**STAFF RECOMMENDATION**  
**1504 Elmwood Avenue**  
**June 20, 2012**

**Application:** Infill and New construction—accessory structure  
**District:** Belmont-Hillsboro Neighborhood Conservation Zoning Overlay  
**Council District:** 18  
**Map and Parcel Number:** 10513011200  
**Applicant:** Rigid Development (Brent Craig)  
**Project Lead:** Melissa Baldock, melissa.baldock@nashville.com

<p><b>Description of Project:</b> Applicant proposes to construct a new one-and-a-half story house and a two-story accessory structure on a vacant lot.</p> <p><b>Recommendation Summary:</b> Staff recommends approval of the construction of the infill building and accessory structure with the conditions that:</p> <ol style="list-style-type: none"> <li>1. The applicant submit new drawings indicating how the grade will be addressed in the new construction, particularly as it relates to the infill’s foundation line and the overall height of the house. (The foundation should have a maximum height of about two feet (2’)).</li> <li>2. Staff approve the house’s asphalt shingle color, final door design, a brick sample, porch floor and stair material, porch railing material, and the porch column shaft m

RIGID DEVELOPMENTS, LLC  
 DETACHED GARAGE  
 20x24 SQ FT.: 434  
 DATE: 06/05/11

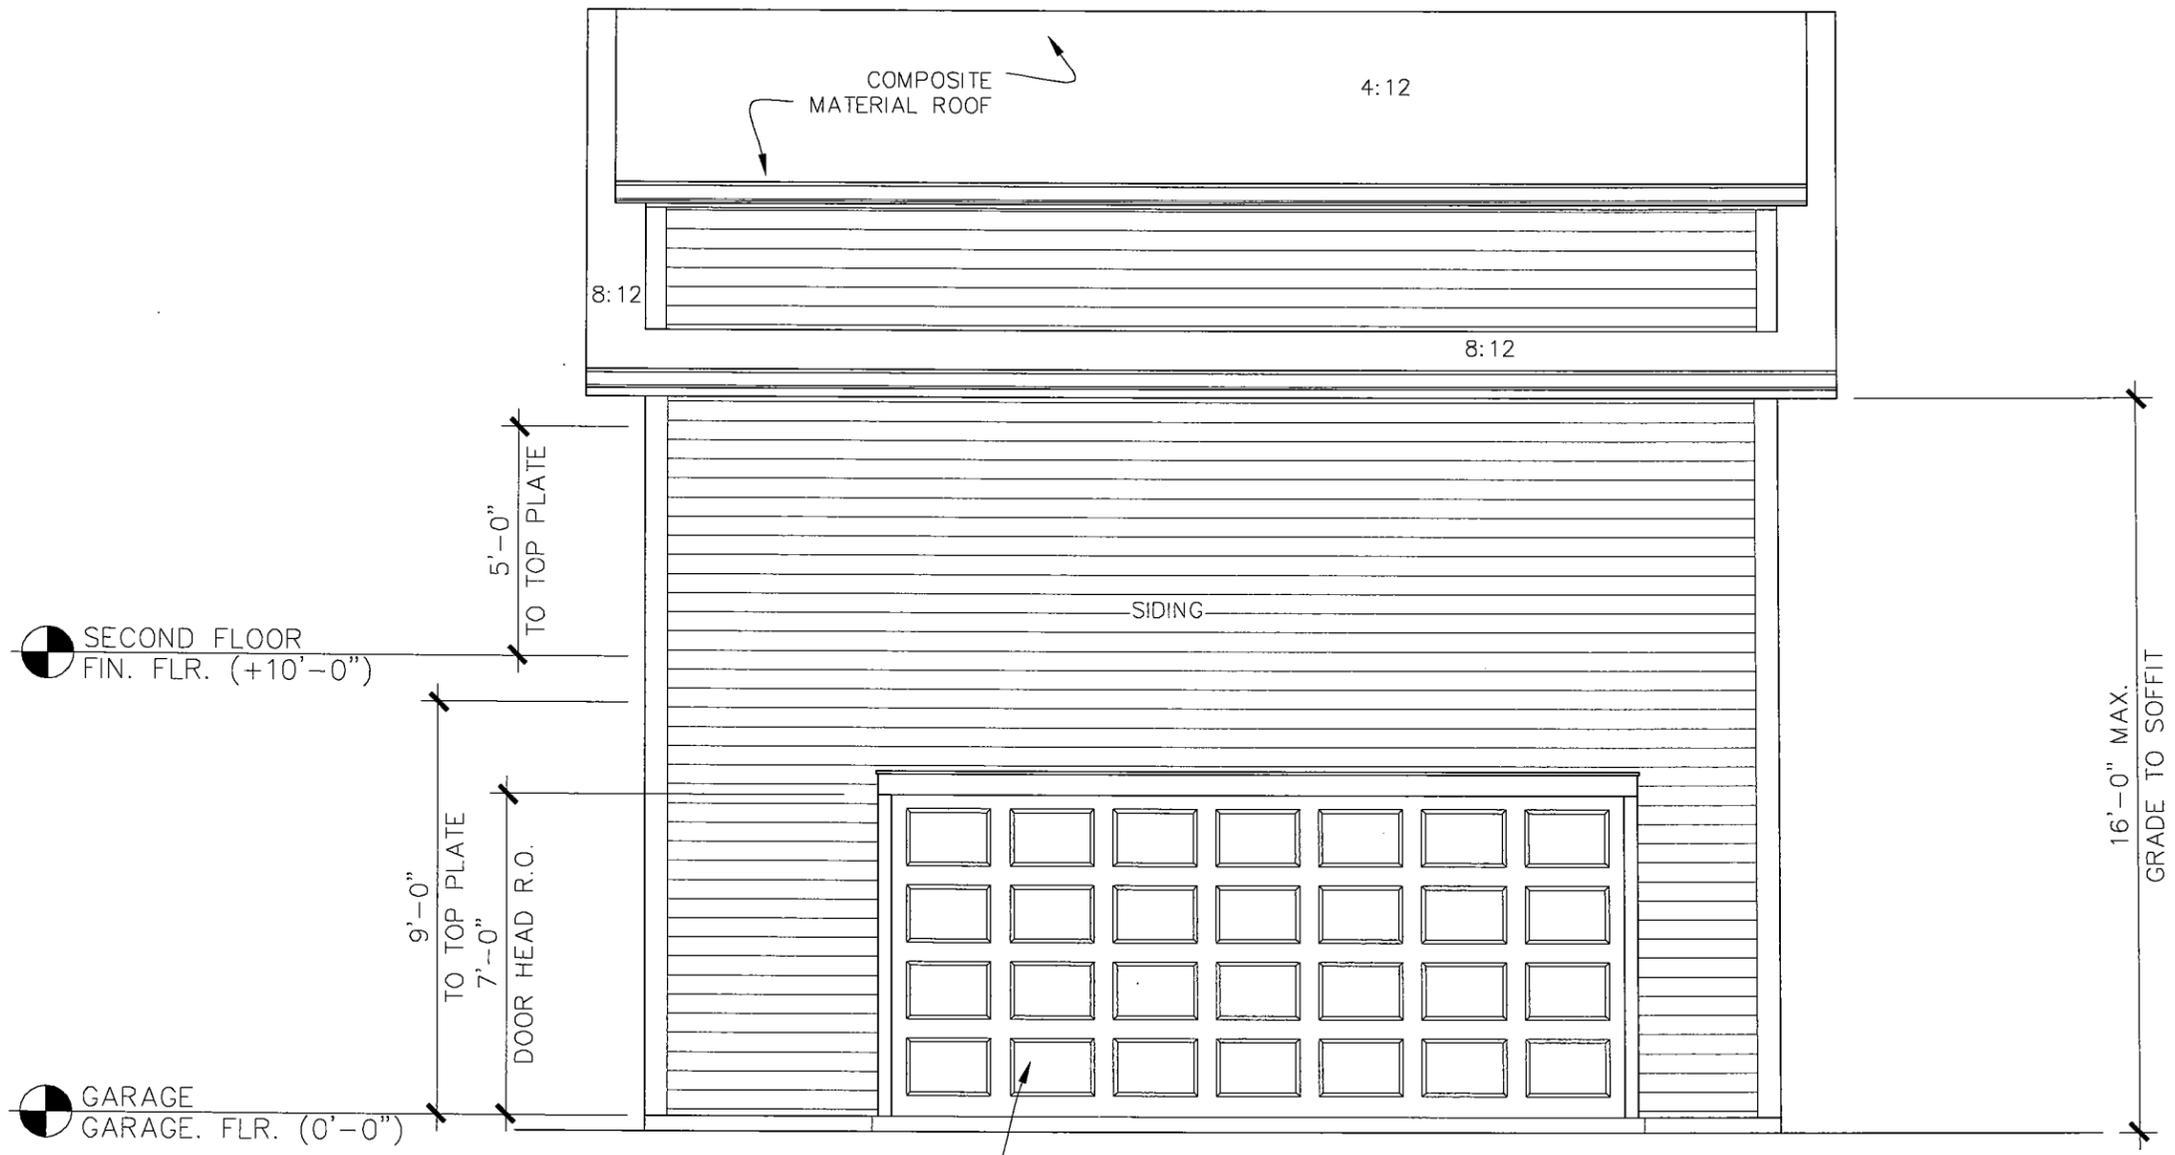
Outbuilding: The project includes a detached accessory structure that is twenty feet, seven inches by twenty-four feet, seven inches (20'7" x 24'7"). This footprint is subordinate to the primary house. The structure meets all base zoning requirements for setbacks, and will be accessed via the alley with garage doors facing the alley. The materials for the structure will be cement fiberboard siding and composite shingle roof. Staff asks to review and approve the window and door materials and specifications and the roof color prior to purchase and installation of these materials.

The accessory structure is proposed to have an eave height of sixteen feet (16') and a ridge height of twenty-four feet, six inches (24'6"). Since the site slopes up towards the rear of the lot, staff finds that more information is needed regarding the slope of the site before determining whether or not the height of the accessory structure is subordinate to the proposed infill. Staff also asks that a trim board be added to the garage at the floor level to help minimize the perceived height of the structure.

6. Staff review the height of the accessory structure relative to the slope of the site prior to permitting to ensure that it is subordinate to the infill.

7. A trim board be added to the accessory structure's floor level, and staff approve all of the structure's windows, doors, and roof color.
